Appeal of Planning Commission Resolution No. 26-05 Regarding Coastal Development Permit No. 19-012 (25200 Pacific Coast Highway, APNs 4459-013-021 and 4459-014-018; Owner, PAR PCH, LLC; Appellant, Jun Hall for Concerned Citizens of Malibu Road, Inc.)

Malibu City Council
Special Meeting Agenda

Wednesday, August 19, 2026

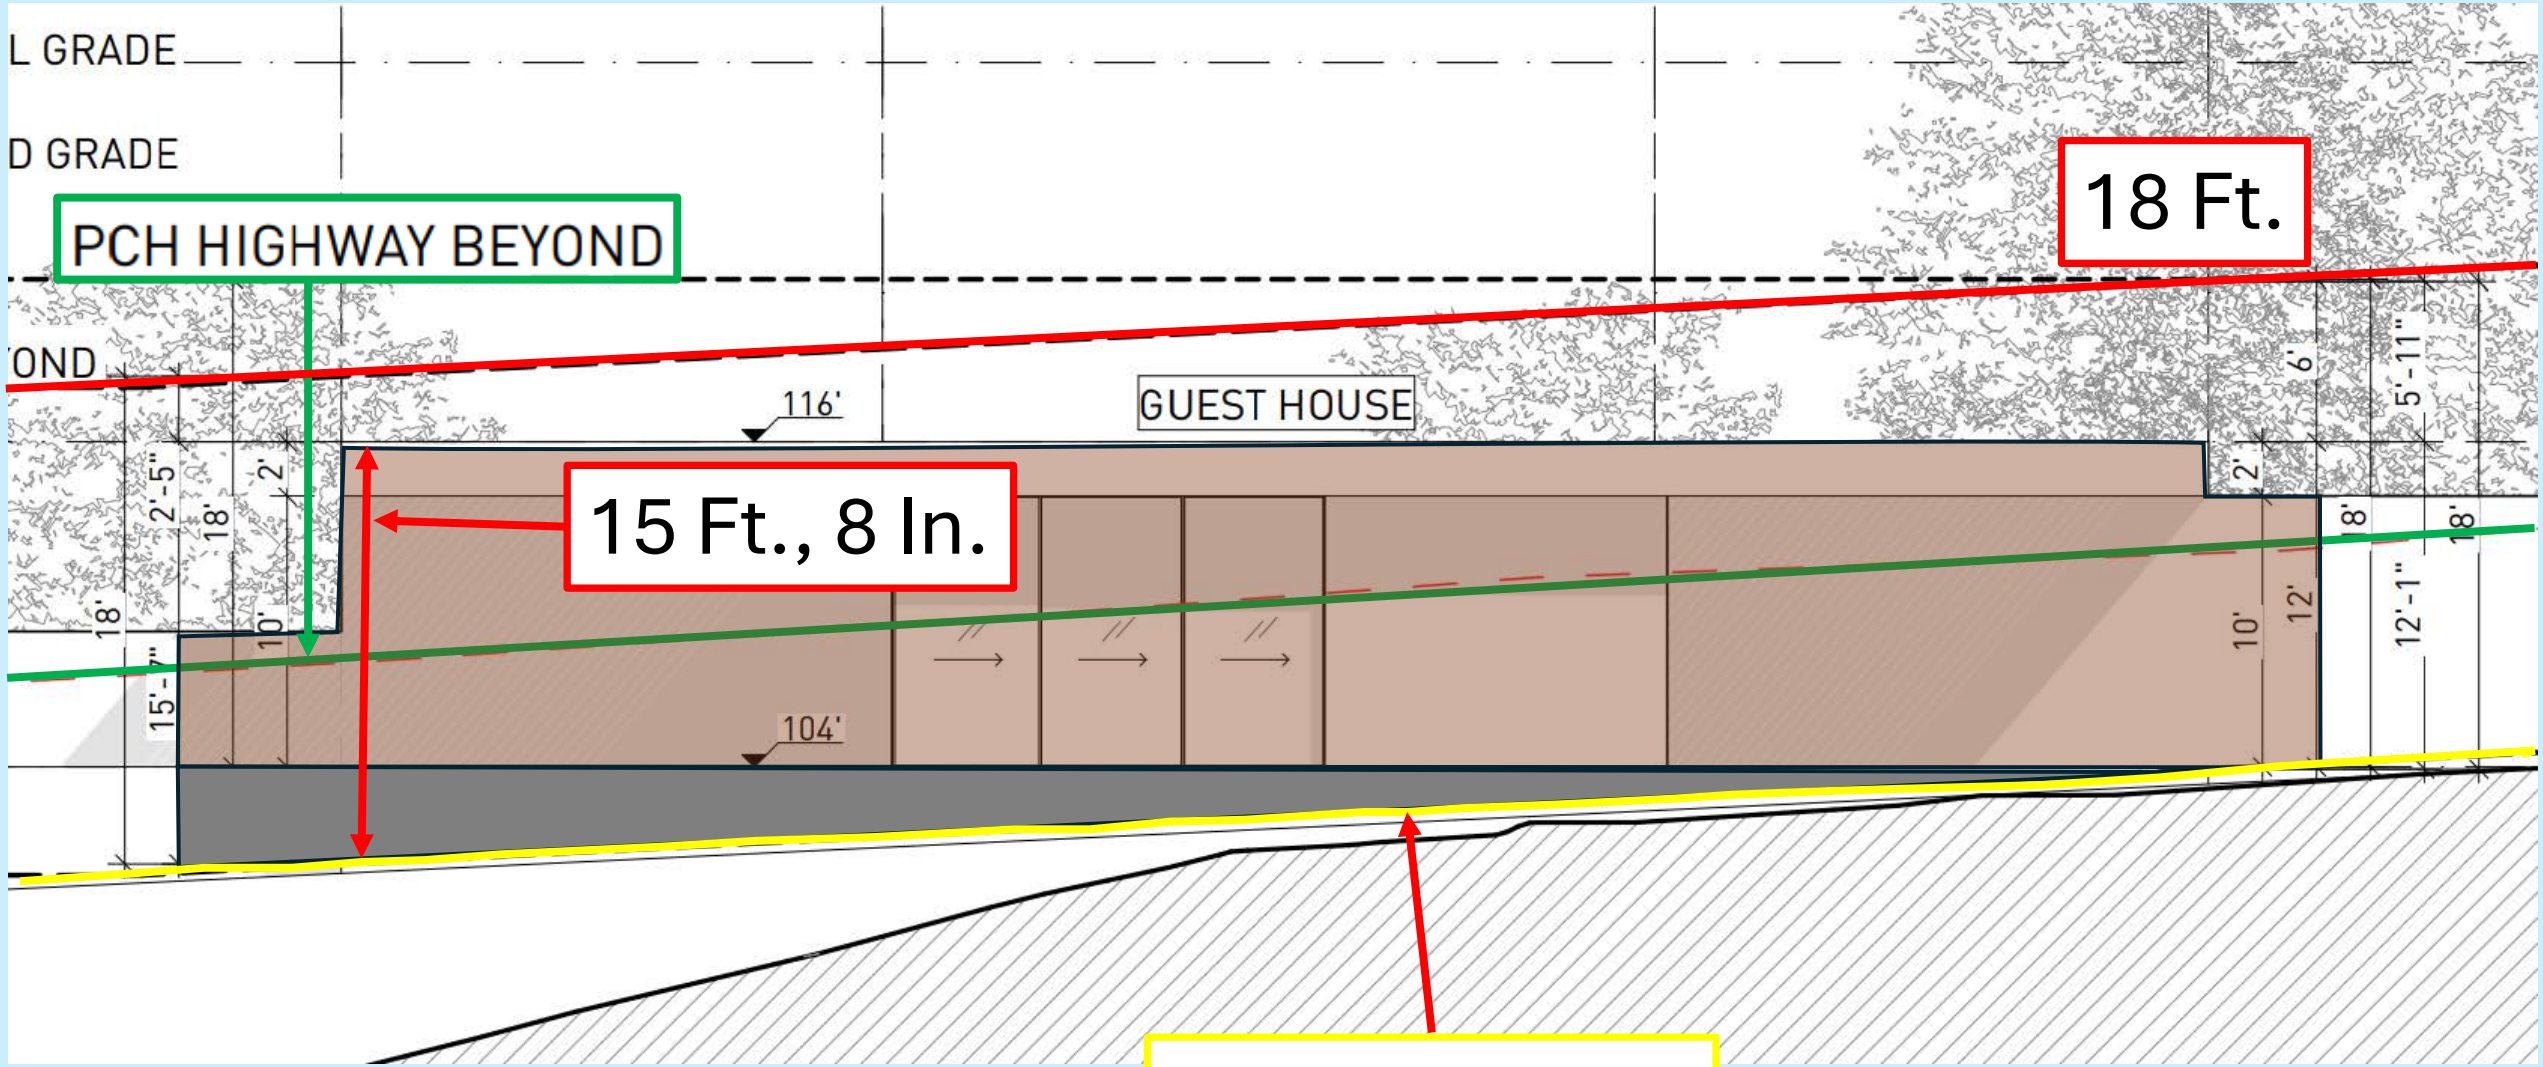
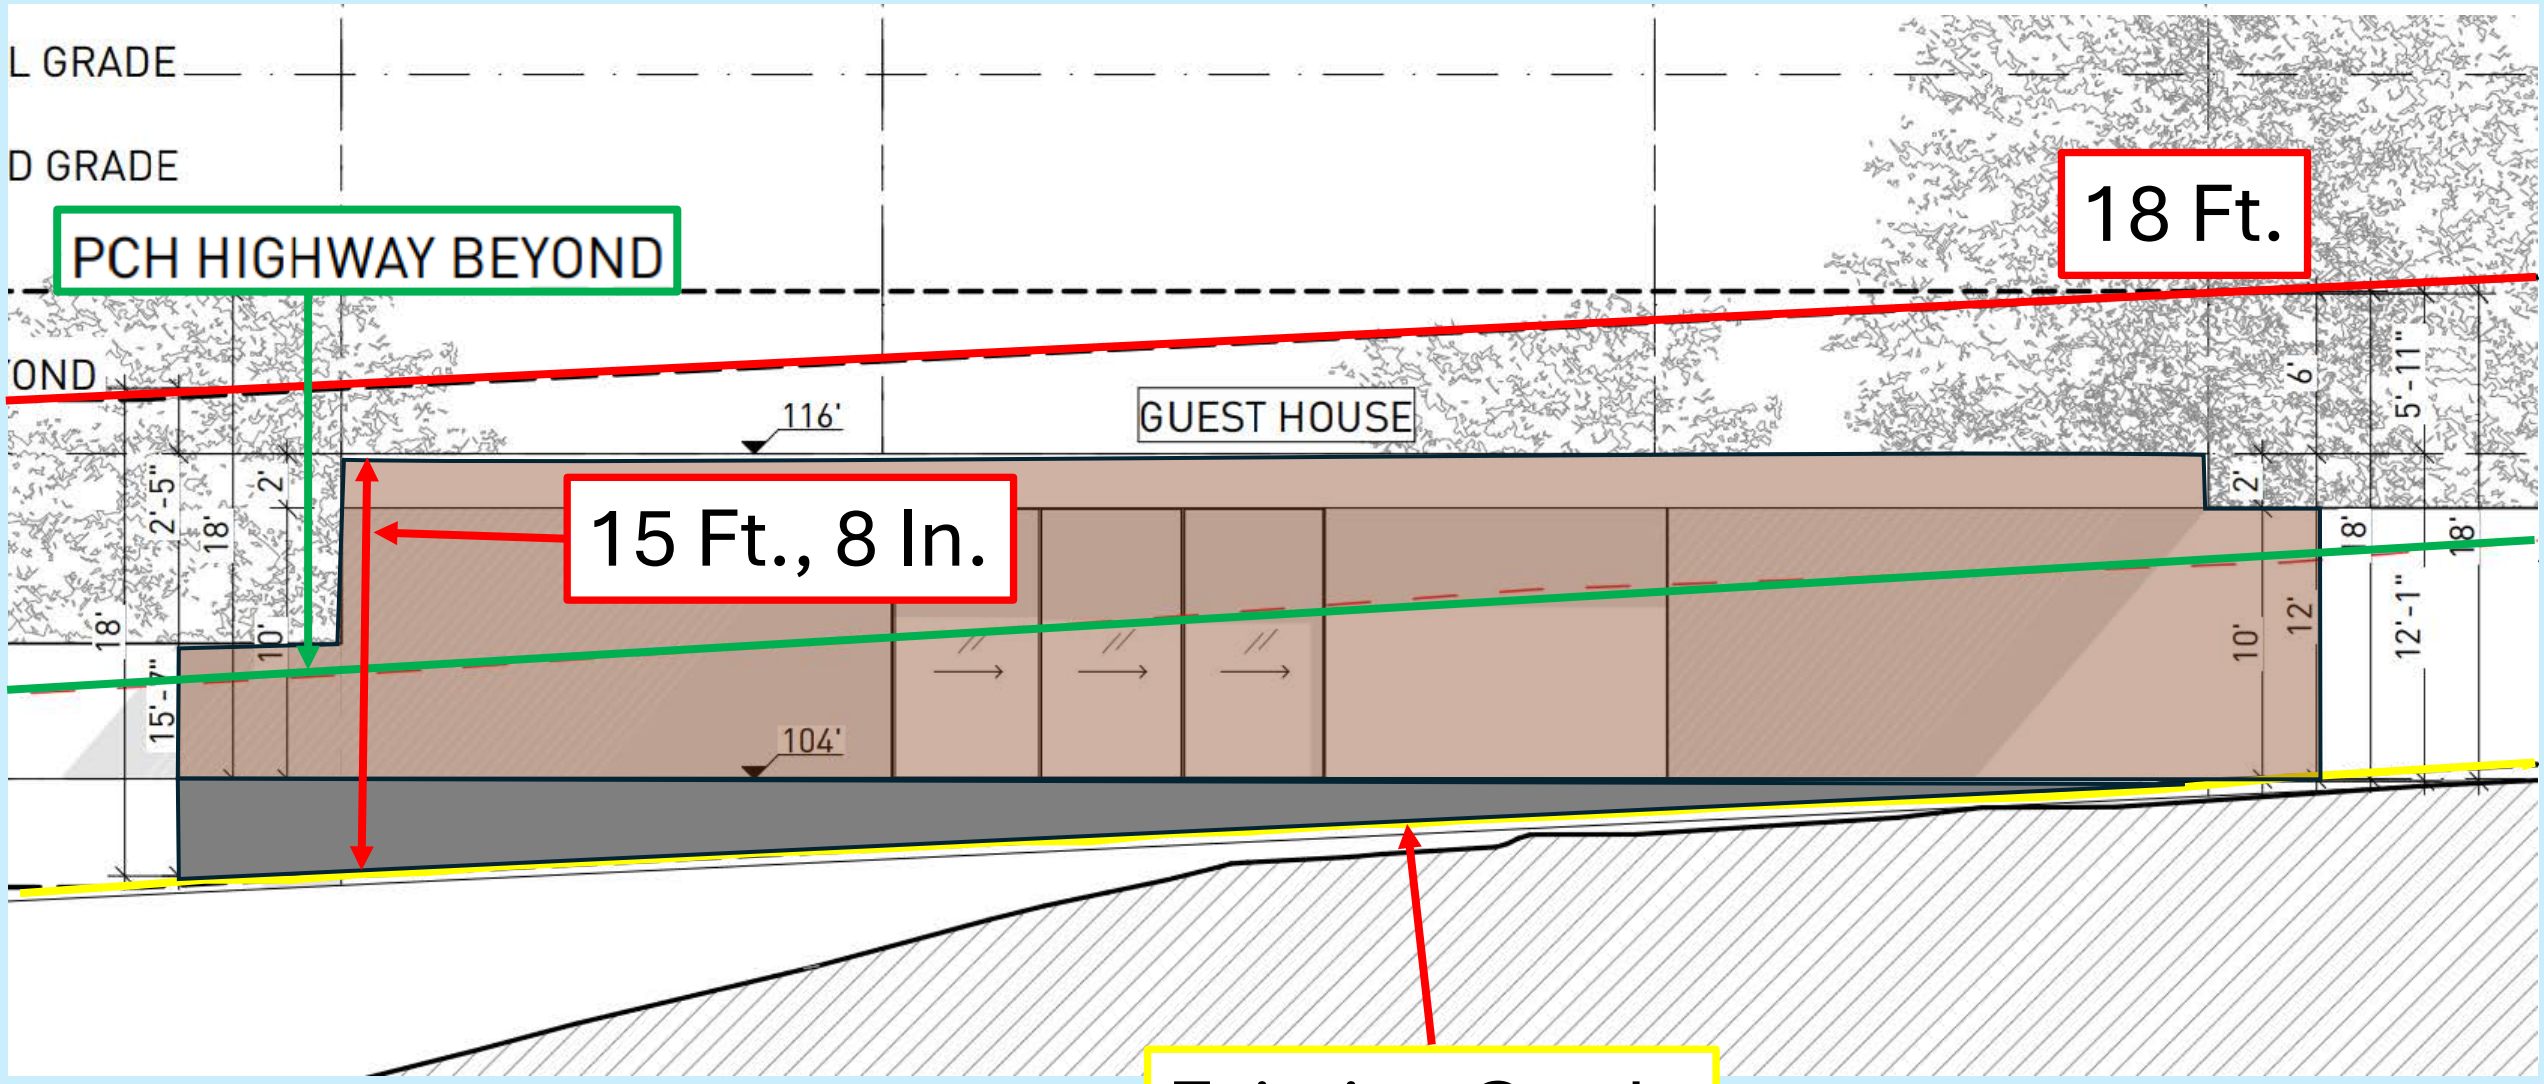
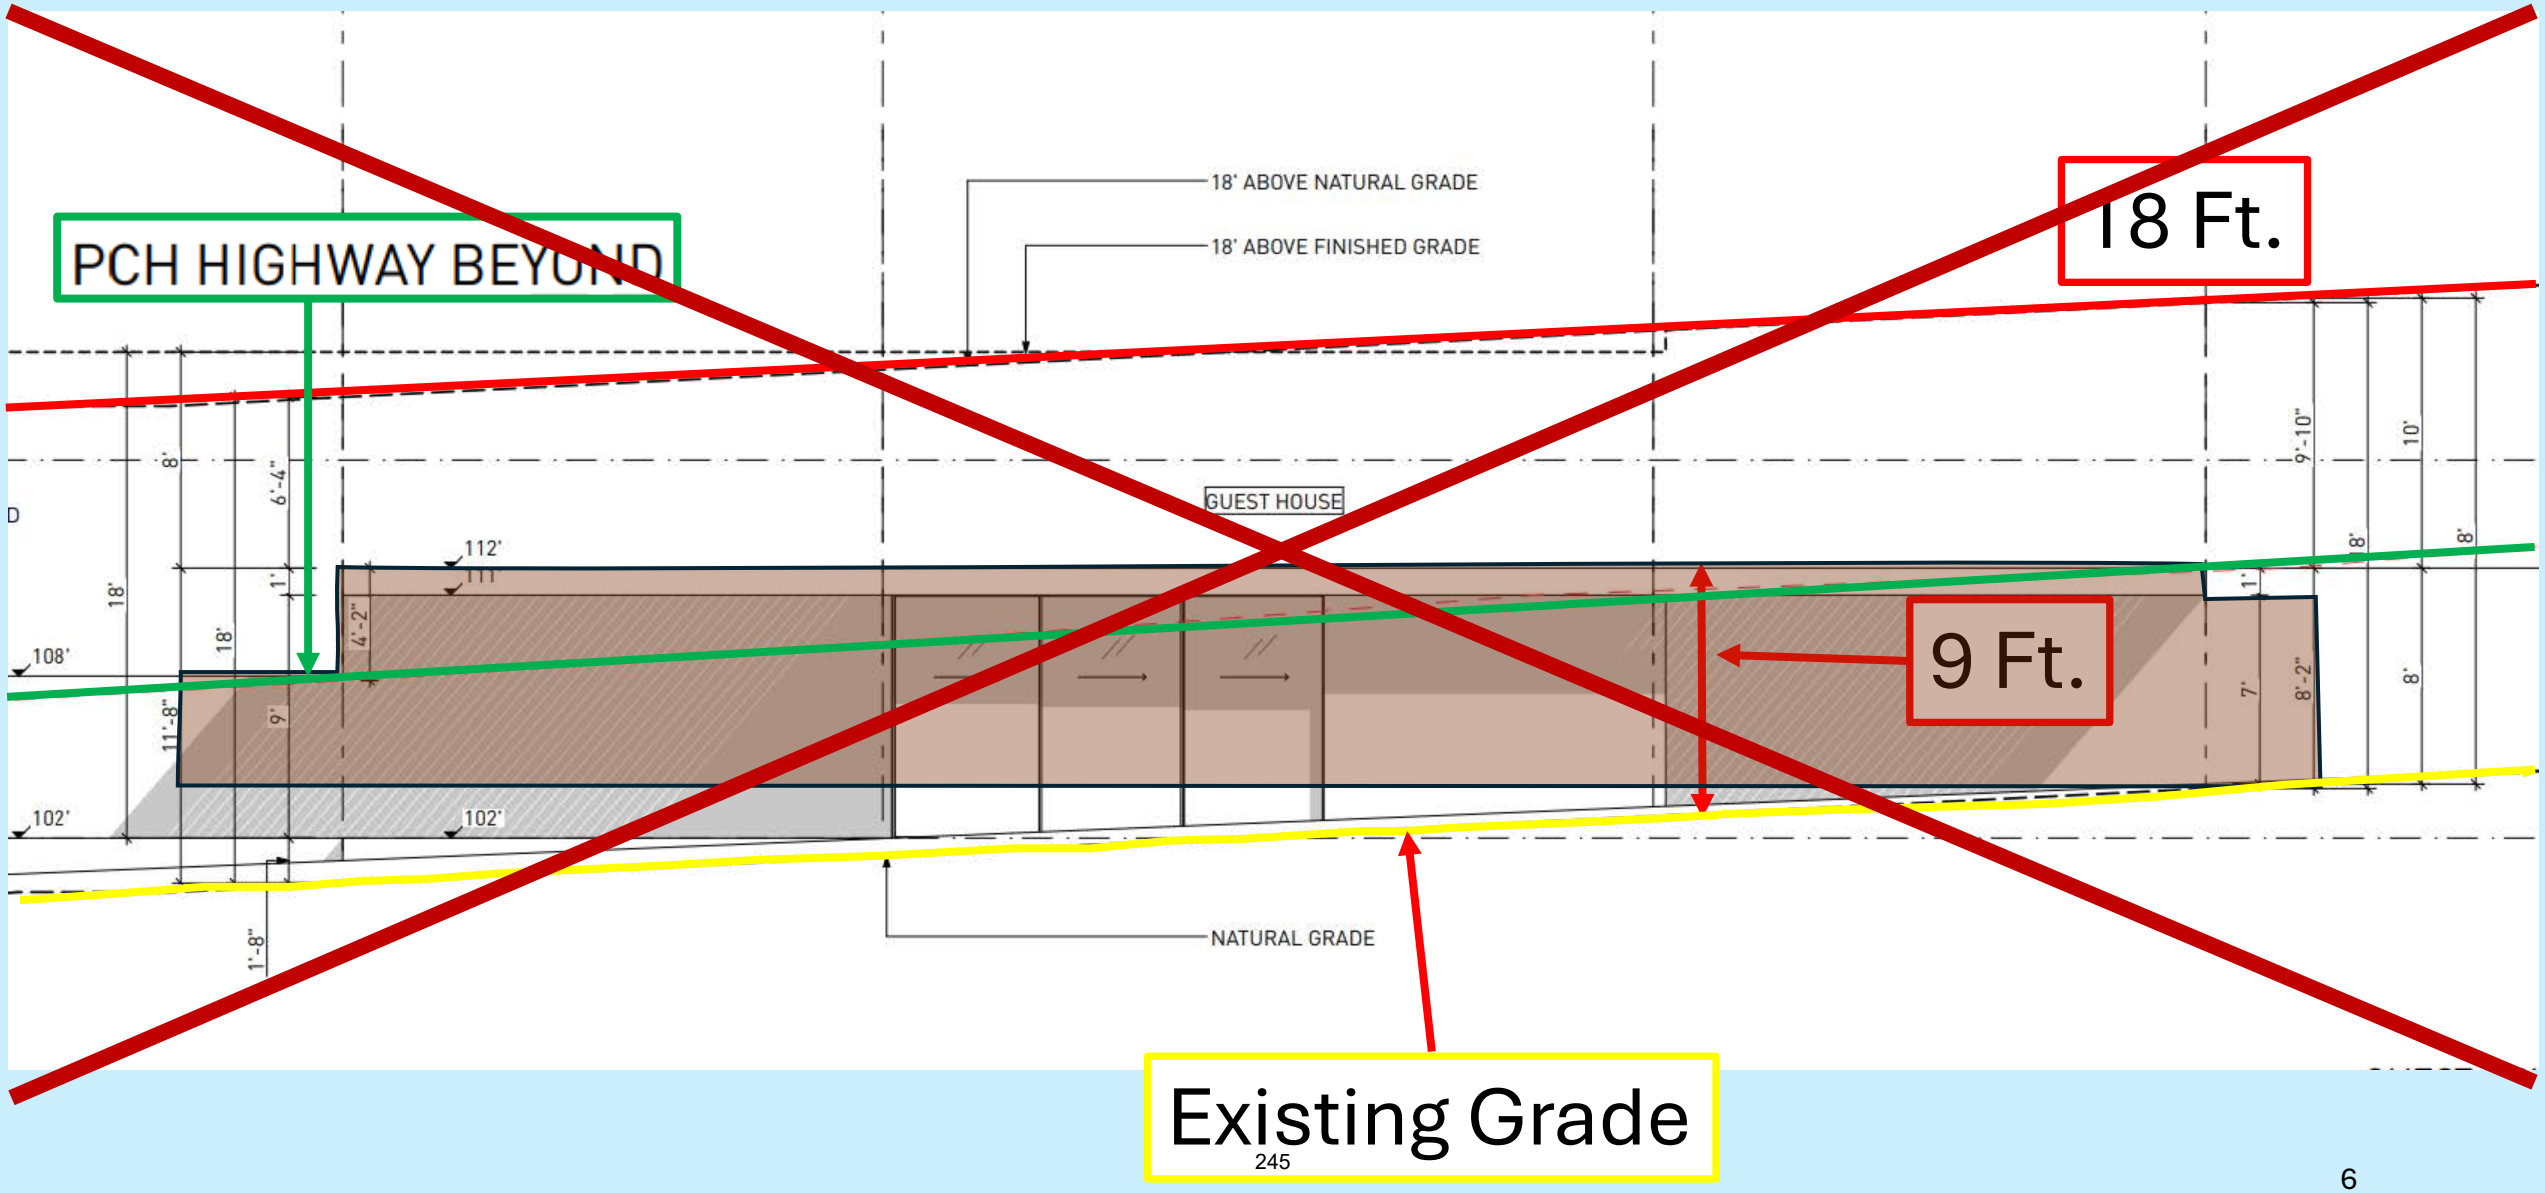
Guest House Height Originally 15 Feet, 8 Inches

Guest House Height Originally 15 Feet, 8 Inches

Guest House No Longer Part of Application
